# GUAM POWER AUTHORITY

AMENDMENT NO.: IX

INVITATION FOR MULTI-STEP BID NO.: GPA-012-23

RENEWABLE ENERGY RESOURCE ACQUISITION PHASE IV

TRANS-ONE LINE  
 EXISTING  
 NEW  
 UNDER CONSTRUCTION

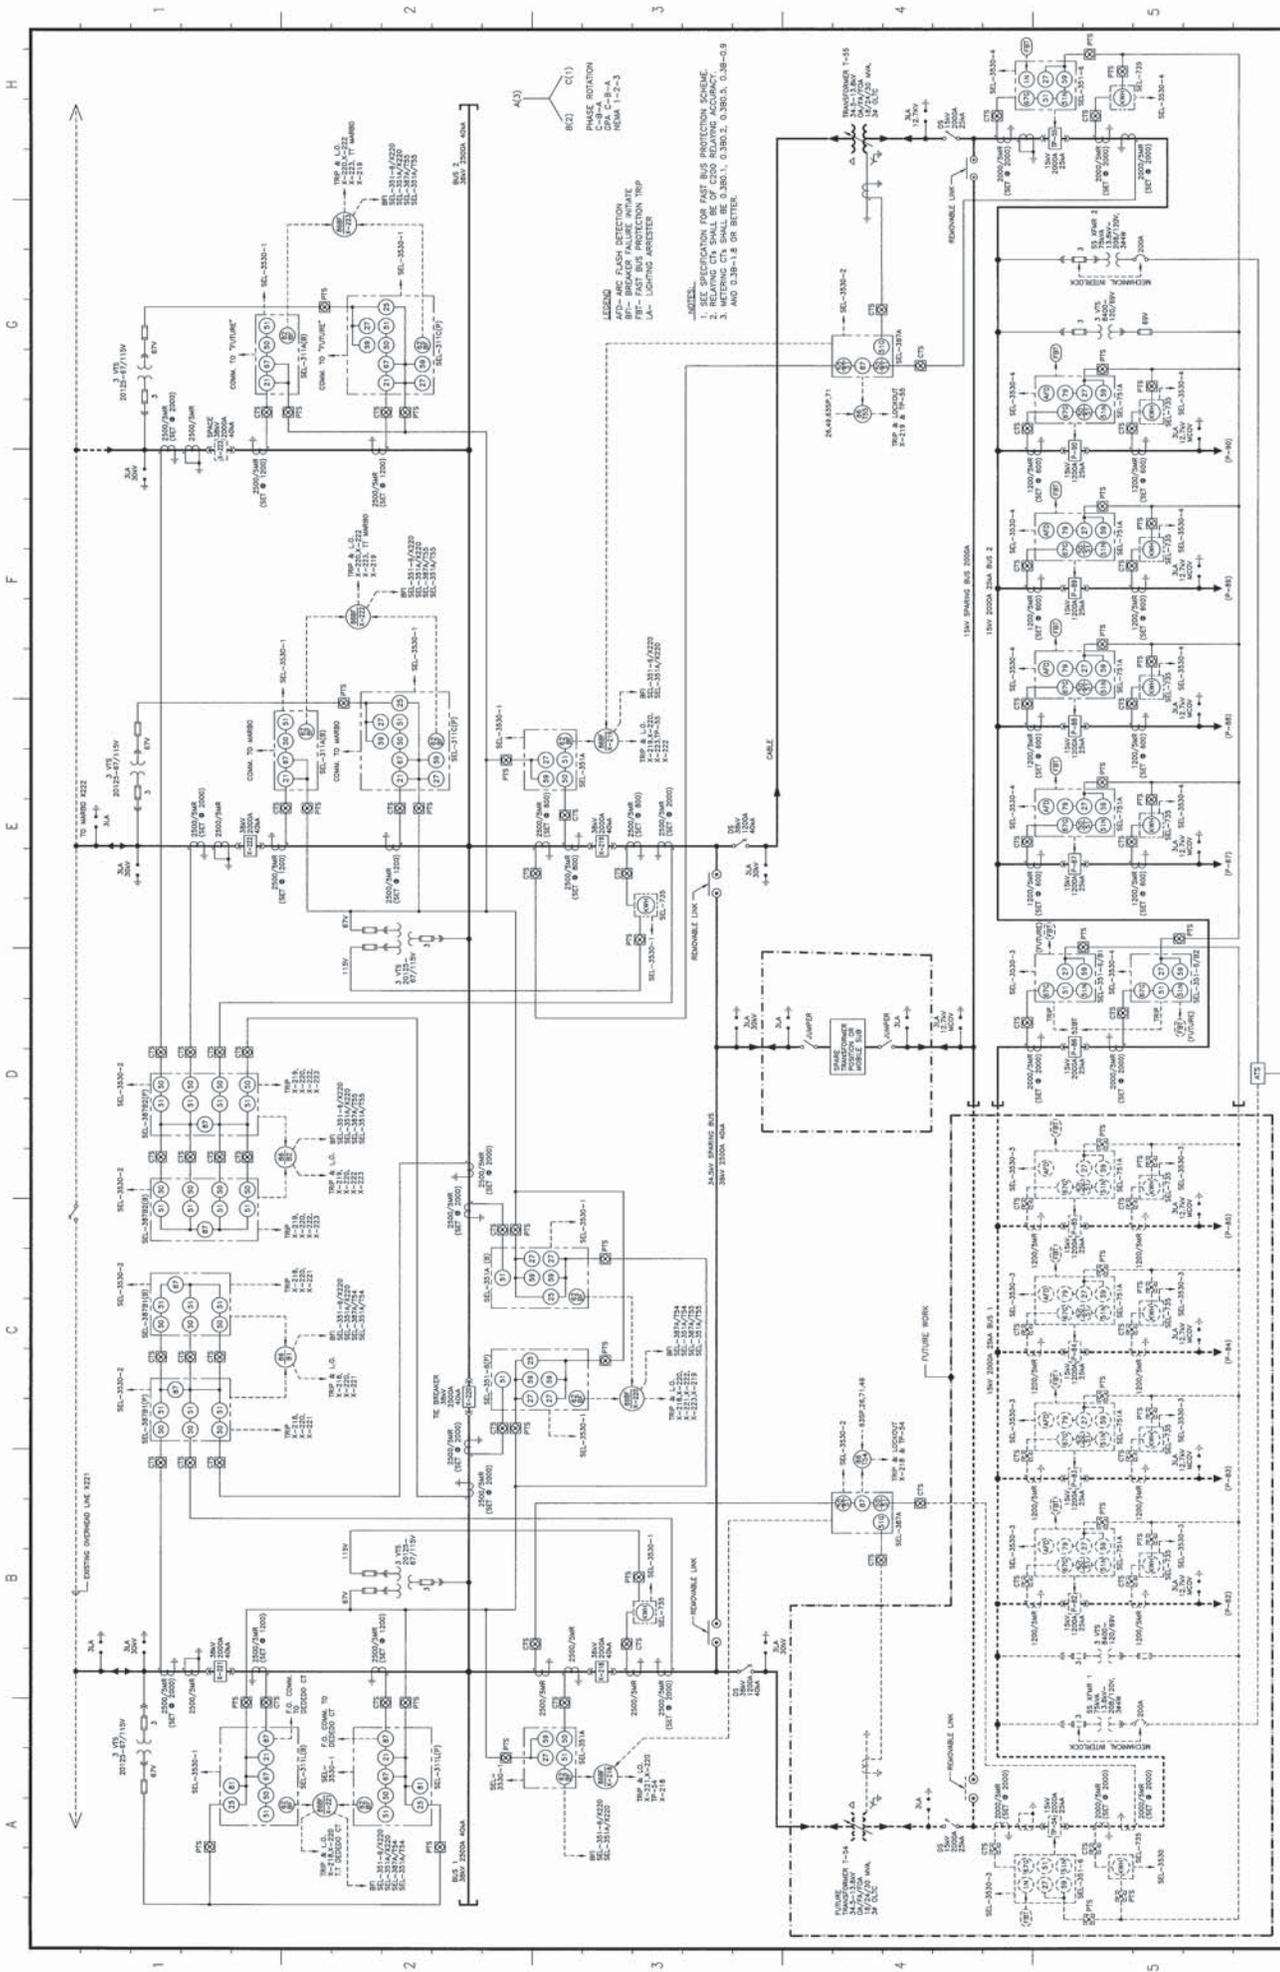
1. **ADD Page 224c of 263 - Transmission One Line 11-15-2022.pdf – Page 1** (see attached).  
**Dededo Indoor Sub Switchgear Drawings – Page 2** (see attached).
